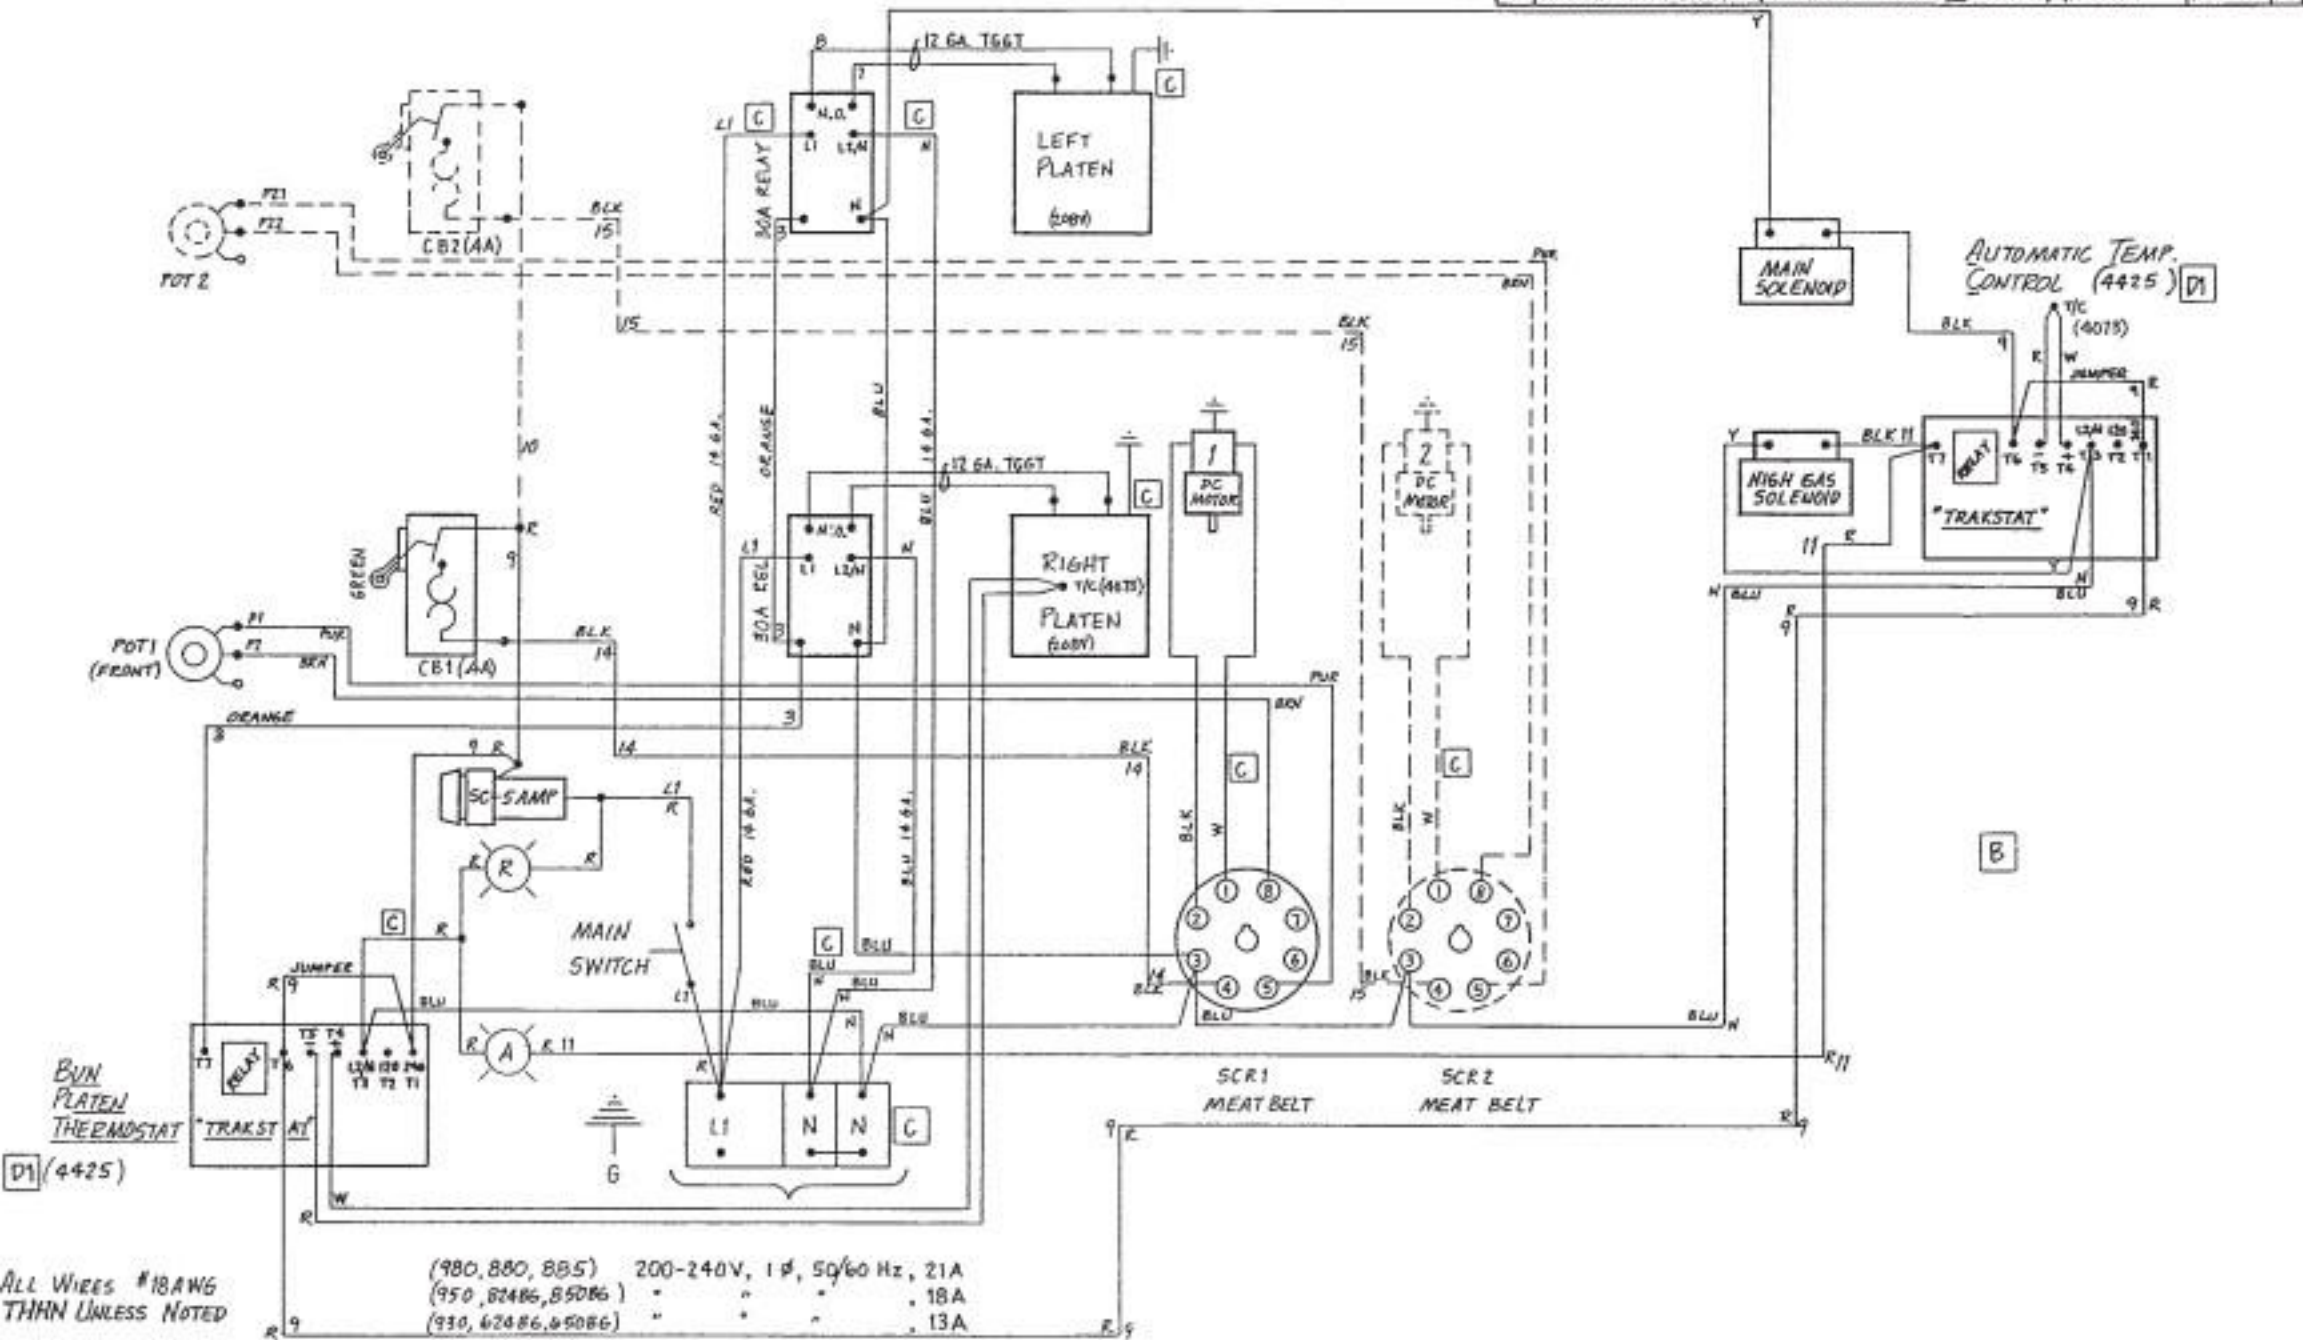
REV.	DESCRIPTION	DATE	BY
A	DELETE DIGITAL DISPLAY. ADD MODEL NO.'S	12-9-94	PZ
B	DELETE OPTIONAL S&P MOTOR / S&P POT / SW.	2-17-95	DZ
C	DEL. RECEPT., ADD 'W' BLOCK, CHG. 'W' TO BLUE, ADD SUP. 14 GA. WIRE; GRAY PLATE	5-31-95	DZ
D	CHANGE TEMP. CONTROL, ADD MODEL NO.'S, WAS [1] "TRAKSTAT", P/N 4071-P	11-2-95	DZ

REV.	DESCRIPTION	DATE	BY
A	DELETE BELT SPEED INDICATOR, ADD MODEL NO.3	12-7-74	DZ
B	DELETE OPTIONAL BED MOTOR/SCR/POT/5W.	2-17-85	DZ
C	DELETE RECEPTALS, MOVE 'N' WIRE W/ INDICATOR LITES, WAS: [1] 4071-P	5-30-75	DZ
D	CHANGE TEMP. CONTROL TO "TRAKSTAT", RN 4425. WAS: [1] 4071-P	7-6-75	DZ
